Priority Level: Medium — Recommended Action		
Attention:	All Service Personnel	Bulletin: SB-042 Date: 2/21/2008
Products:	EA SPORTS™ NASCAR Racing, Standard Cabinets Only	
Issue:	Cabinet sections may separate after rough handling.

Figure 1 of 2

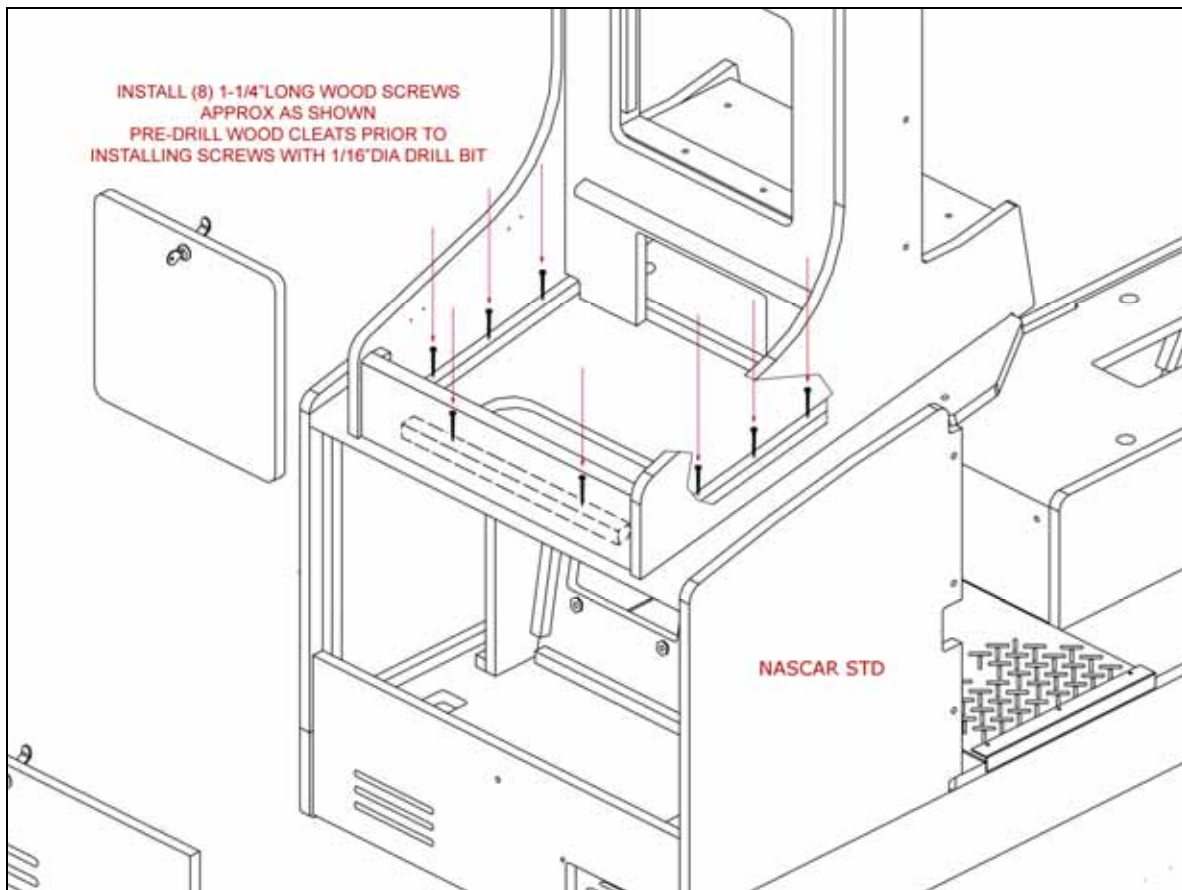
Symptom: A small number of EA SPORTS™ NASCAR Racing Standard Cabinets have had incidents of cabinet sections separating, particularly after rough handling during shipping.

Solution: As a proactive approach, GLOBAL VR recommends reinforcing the cabinets by installing screws as shown in the two drawings in this bulletin.

Important: Pre-drill each hole with a 1/16-inch drill bit to prevent splitting the wood cleats.
